## ArevaEPRDCPEm Resource

Request for Additional Information No. 417(4741), Revision 0

U. S. EPR Standard Design Certification

09.02.02-114

Figure 2.7.1-1—Component Cooling Water System Functional Arrangement  
Sheet 10 of 11

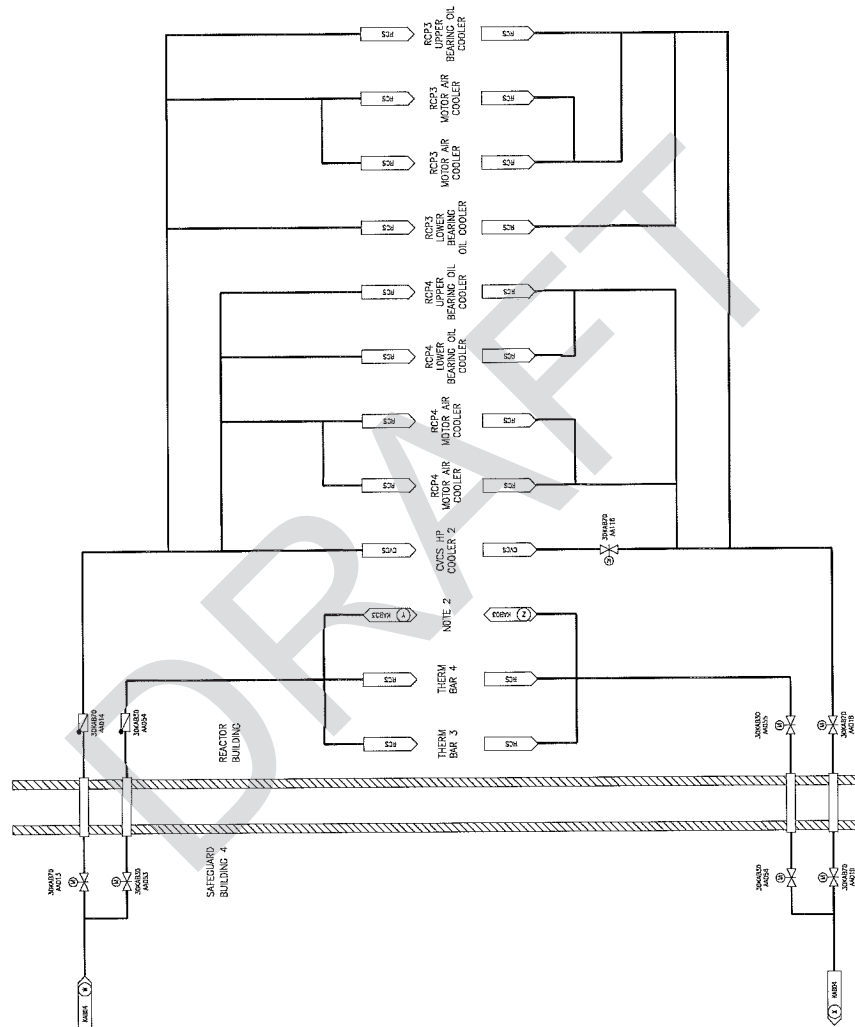
Another interlocking function is required concerning the cooling paths of the Common 1b and Common 2b headers toward the reactor coolant pump (RCP) thermal barriers. Either the Common 1b or 2b headers can provide cooling to the RCP thermal barriers. To maintain strict CCWS train separation, the containment isolation valves (CIV) on the RCP thermal barriers cooling path on the supply and return side of Common 1b cannot be opened unless the CIVs on both the supply and return side of Common 2b are closed, and vice versa. The functional logic for the CIV interlock is shown in Figure 7.6-2.

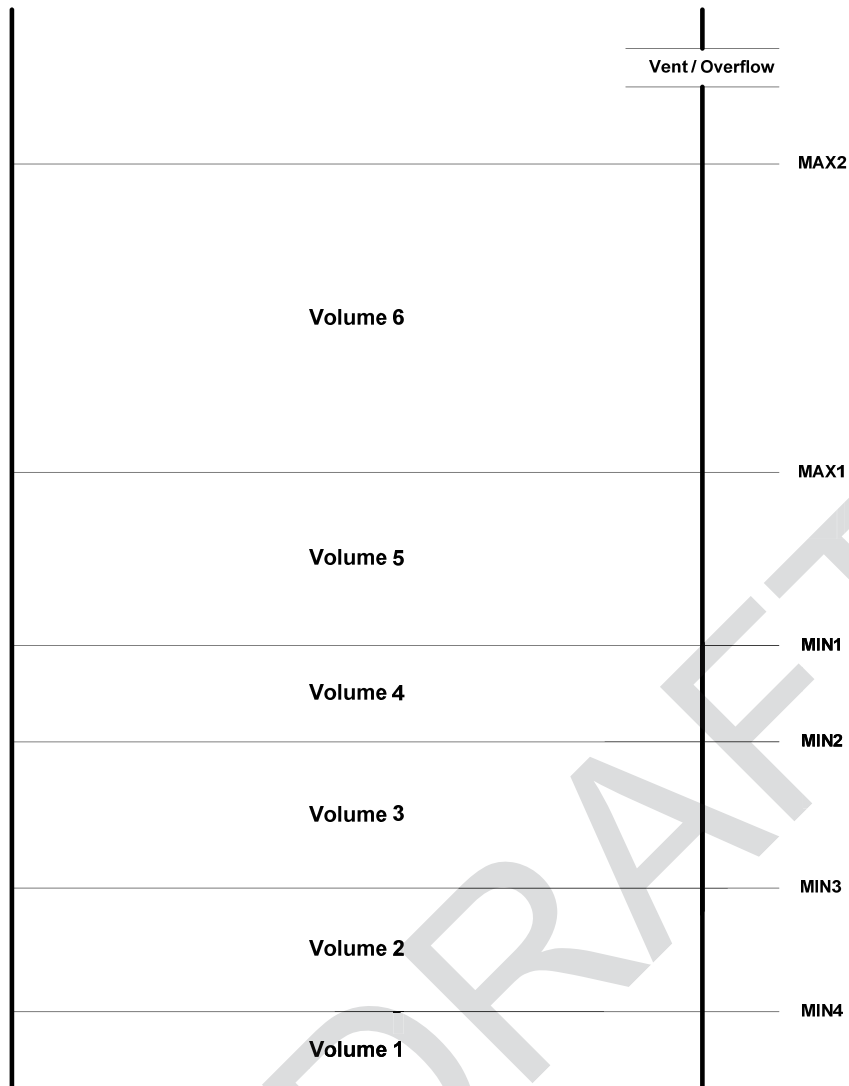
Part (c)1 and (c)2: In Part (c)1 of follow-up RAI 9.2.2-67 the applicant was asked to provide justification for the assumed 1 gpm leak rate and to consider the need to account for leakage through large diameter closed switchover valves. For Part (c)2 the applicant was asked to similarly consider the impact of any revised leak rate from (c)1 on volume loss from the tank until the initiation of emergency makeup. In response the applicant identified a revised position that assumed leakage of 5 gpm through each of four closed switchover valves (2-24" and 2-16" diameter valves) for a total of 20 gpm per train. This equated to an one hour surge tank leak rate of 1200 gallon.

For the CCWS, the assumed leakage paths are through each of the (2) 16" Common "a" header isolation valves and the (2) 24" Common "b" header isolation valves. Pump seal leakage and miscellaneous valve packing leakage is also considered for each CCWS train. The leakage rate for the CCWS valves will be based on ASME QME-1-2007 for flow control valves that are also intended to serve as isolation valves. Operational Experience will be included in the design of the surge tank volumetric allotment for post-seismic leakage in addition to code calculated valve seat leakage rates. ASME QME-1-2007 identifies a low leakage rate of 0.1 in.<sup>3</sup>/hr/NPS of nominal valve size and a nominal leakage rate of 0.6 in.<sup>3</sup>/hr/NPS of nominal valve size. Assumed pump seal leakage of 100 cubic centimeters per hour and miscellaneous valve packing leakage of 250 cubic centimeters per hour is included in the leakage calculation for each train. The following table summarizes the total train leakage and the total required volume to accommodate continuous leakage for 24 hours/day for 7 days when the nominal rate of 0.6 in.<sup>3</sup>/hr/NPS of nominal valve size is applied. For valve seat leakage, the worst case pressure delta resulting from one CCWS train in service with the associated train for the same common header depressurized is considered.

<b>Leakage Rate (ASME QME-1-2007 Nominal Rate for Valves)</b>
(2) 16" Valves (gal/hour)	0.083
(2) 24" Valves (gal/hour)	0.125
Pump Seal (gal/hour)	0.026
Miscellaneous Valve Packing (gal/hour)	0.066
Train Total (gal/hour)	0.3
Train Total (gal/day) (@ constant for 24 hrs/day)	7.2
7 Day Required Volume (gallons)	50.4
